**April 25, 2017**

**ADDENDUM NO. 1**

**Durham County Courthouse Security System  
RFP 17-031**

# Courthouse 7th Floor

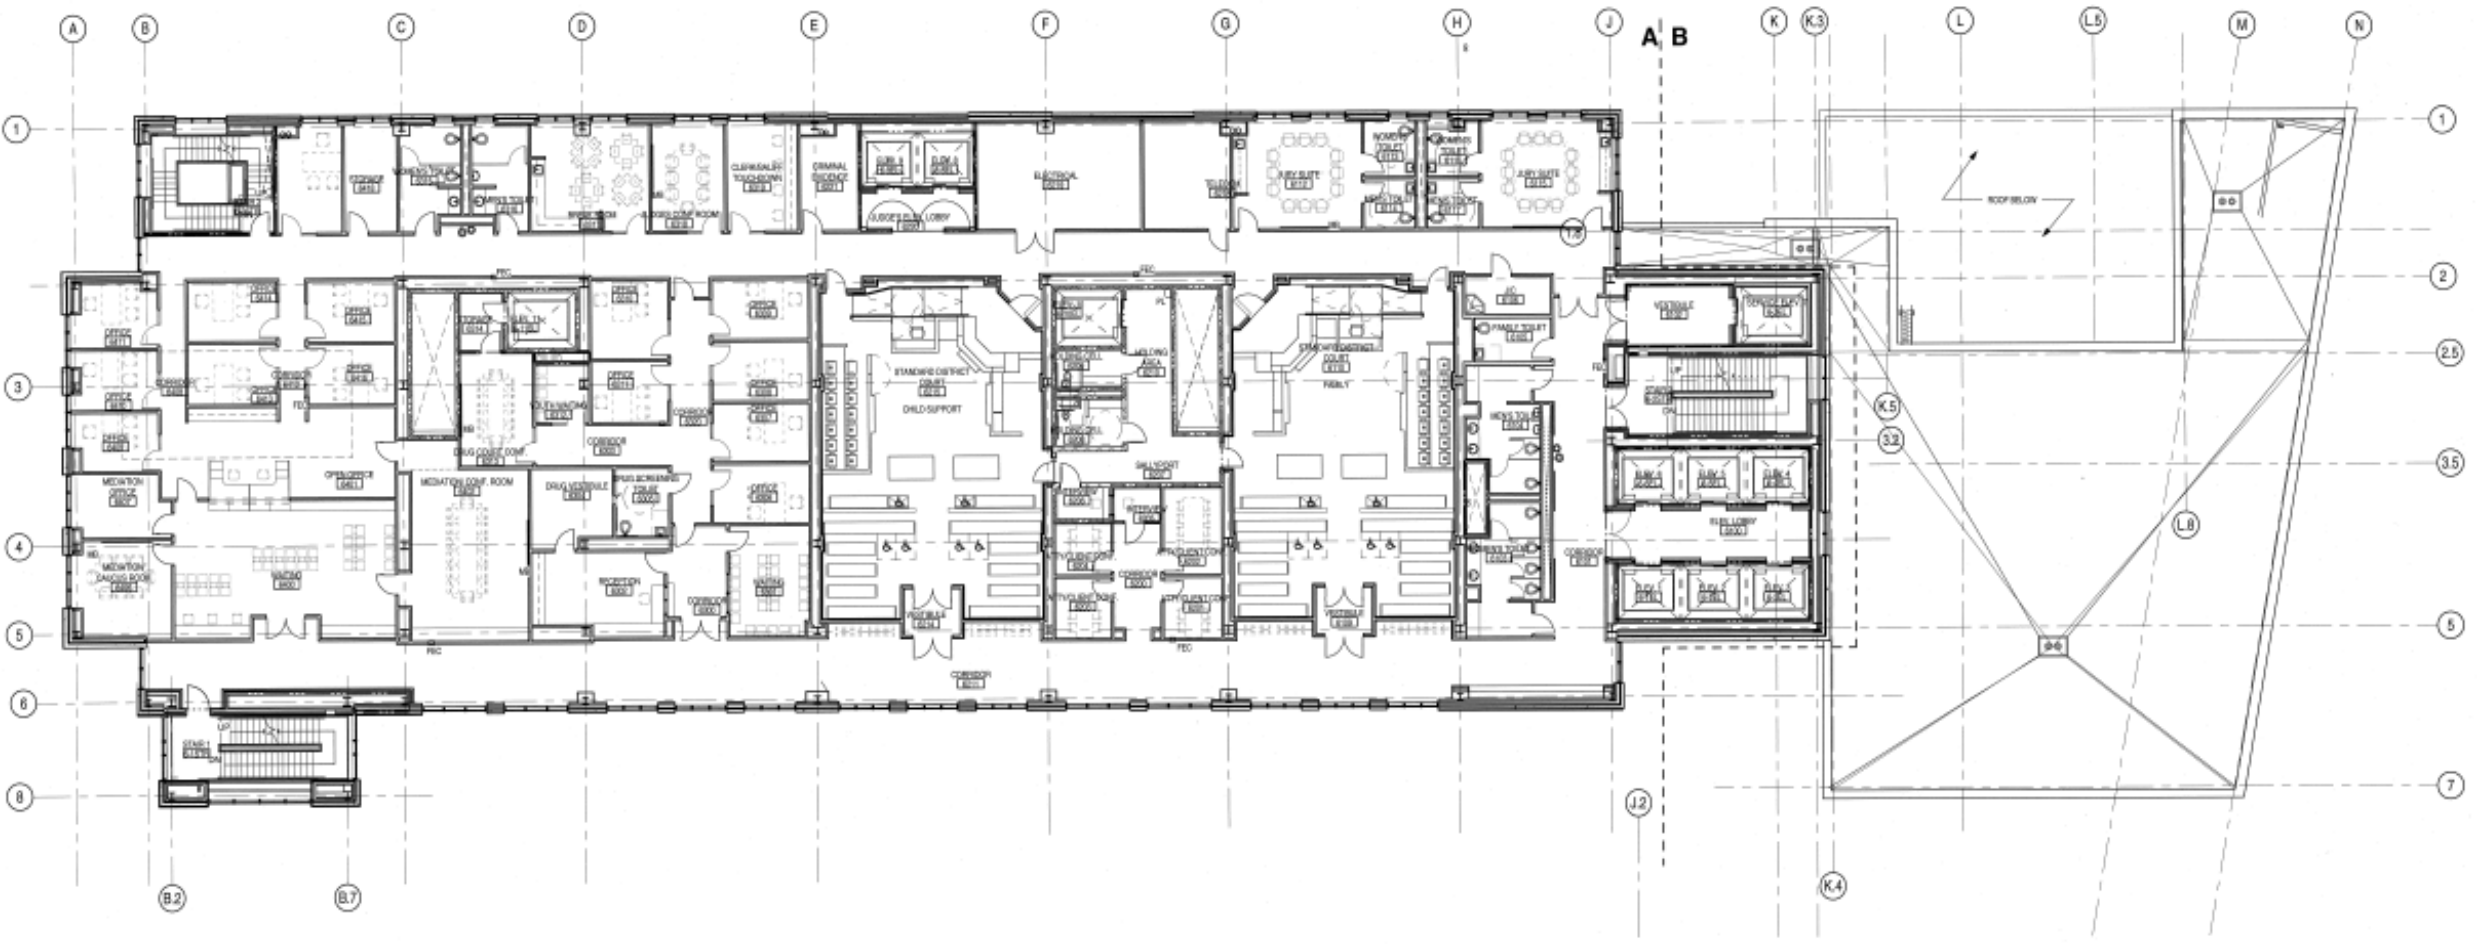
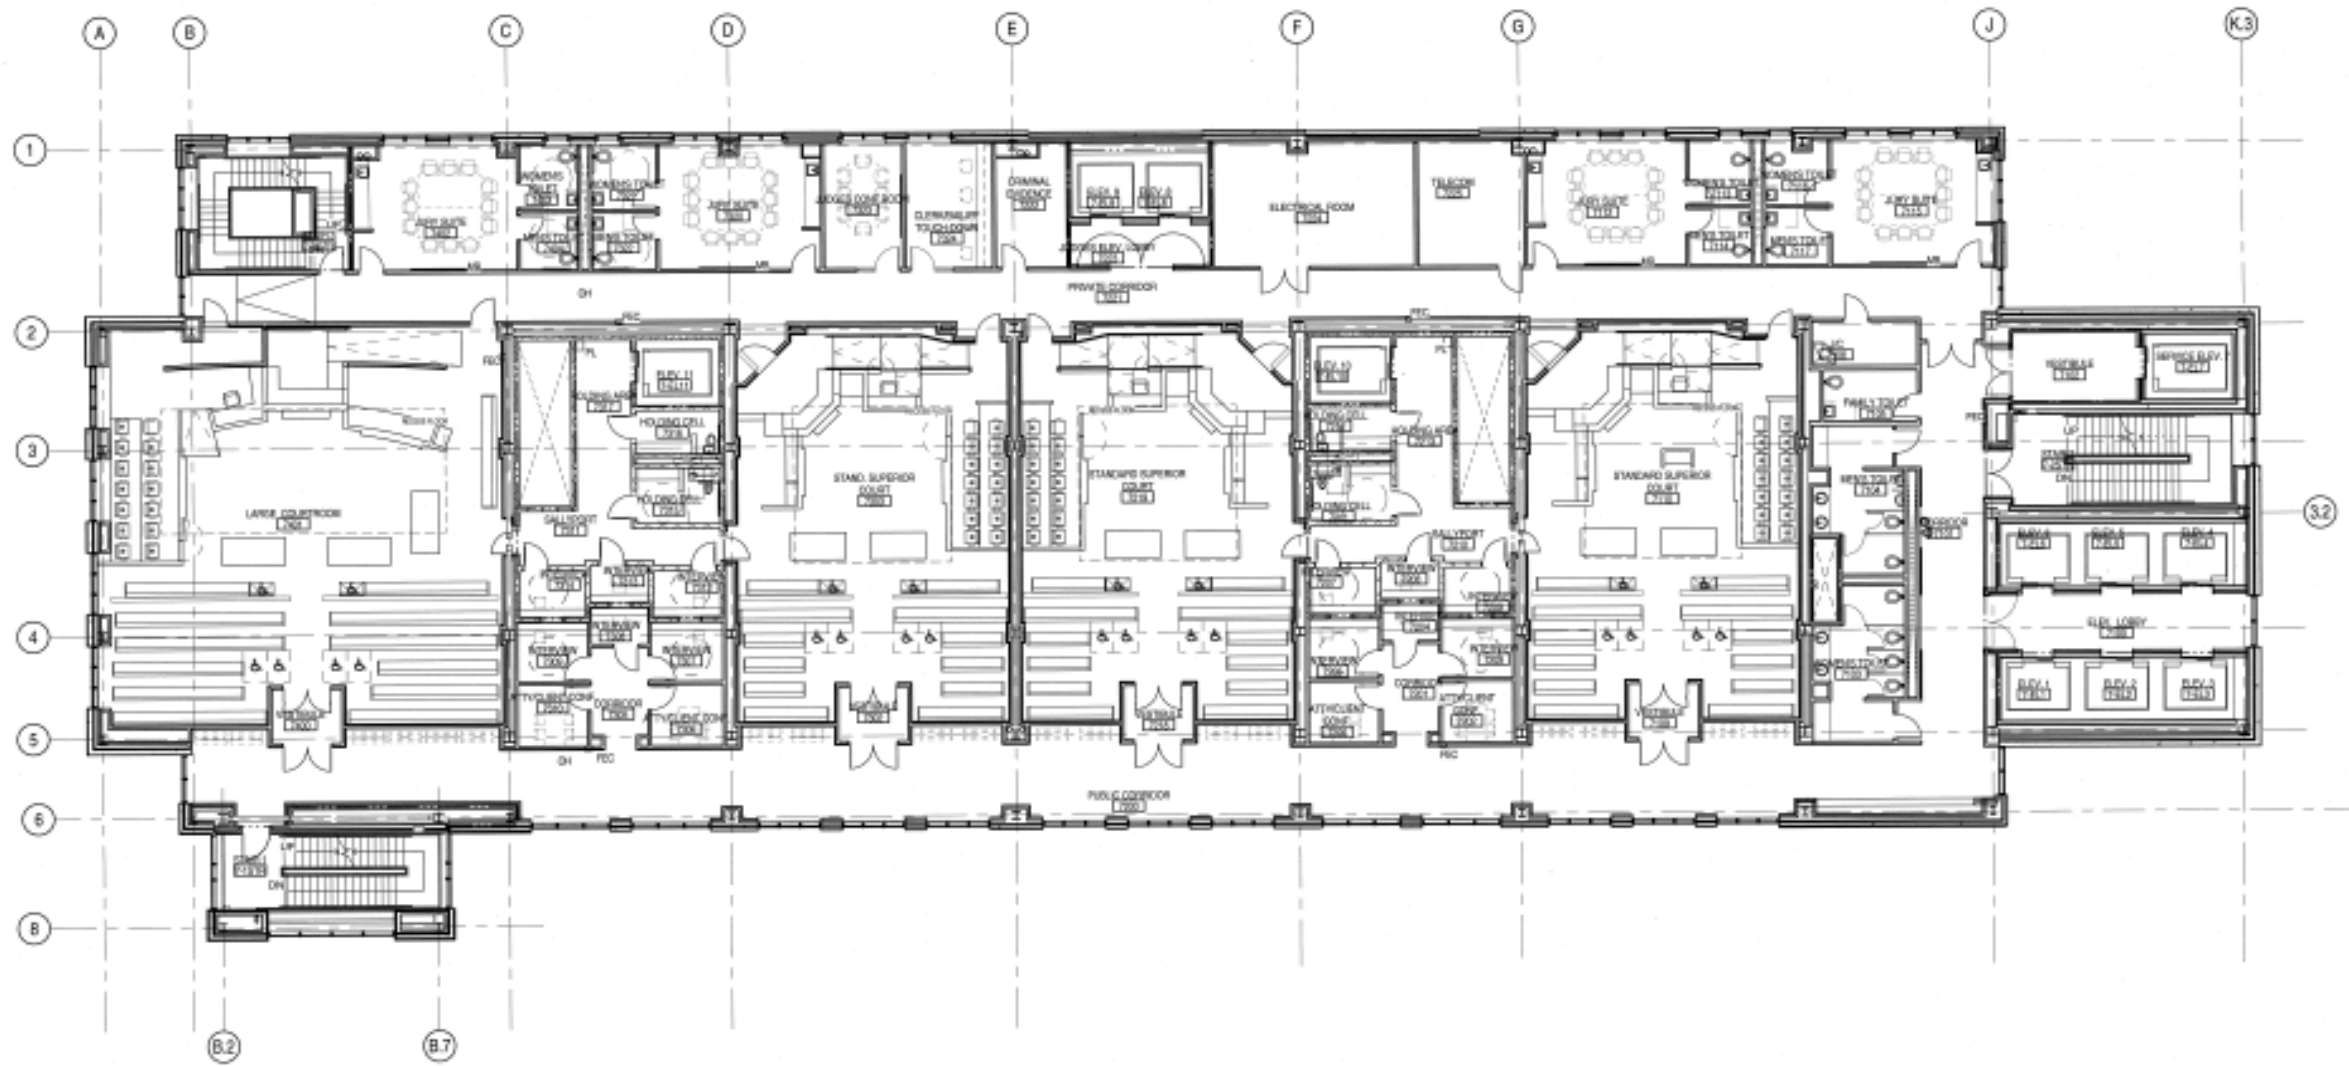
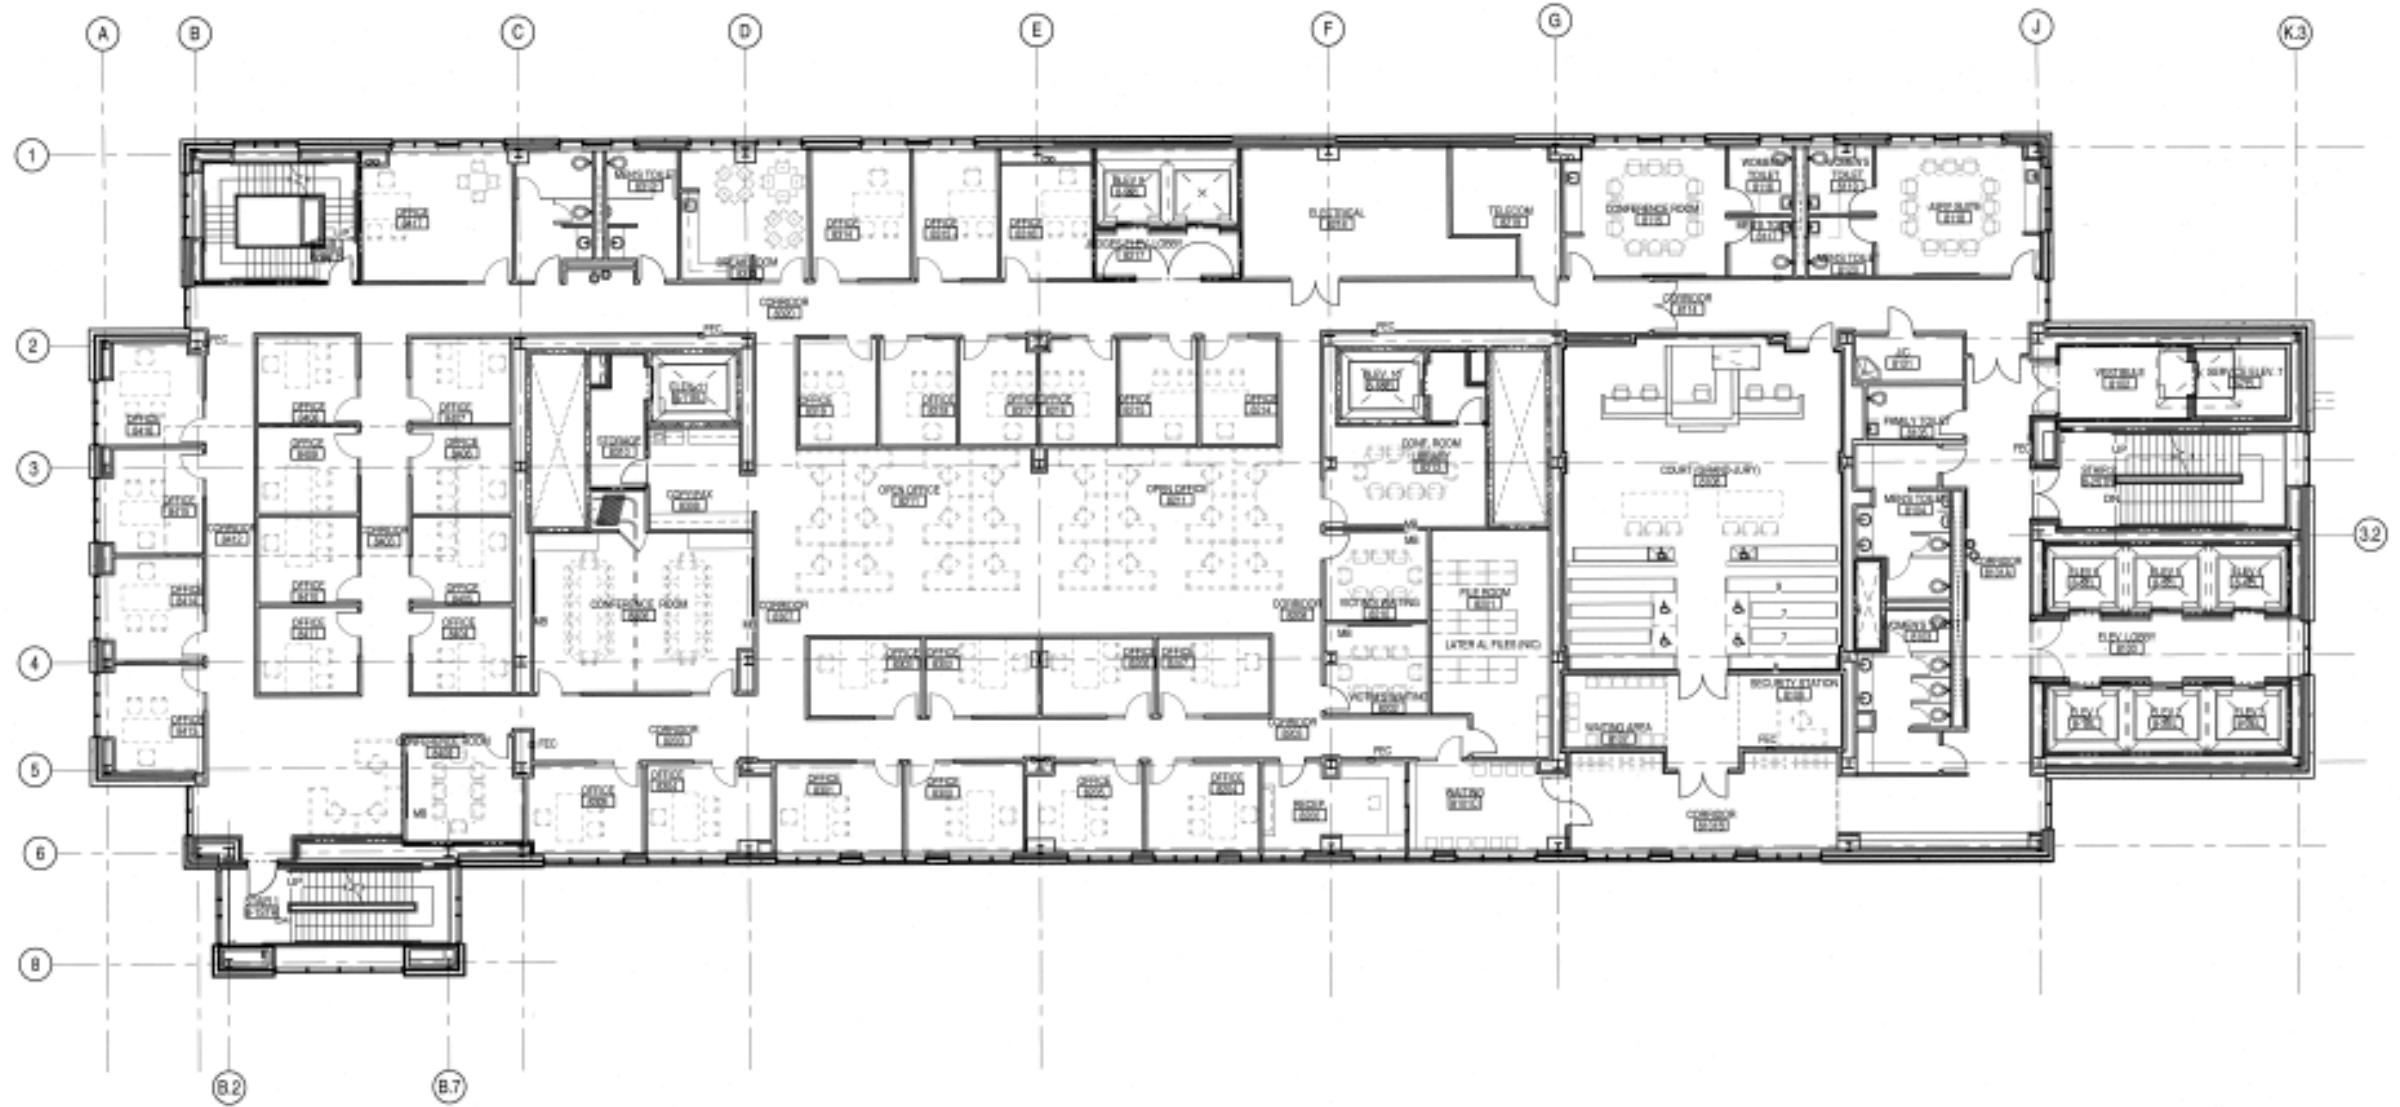
**Question 9** Are Maps required? If so, will CAD files be provided? Or will appropriate MAP files be provided?

**Question 27** Please provide a set of the PDF maps that are to be used in the system. This is to allow for estimating the amount of time to prepare the plans for importing into S2.

**Response** See Attachment 3 Durham County Courthouse Floor Plans

**Response** See Attachment 3, Durham County Courthouse Floor Plans
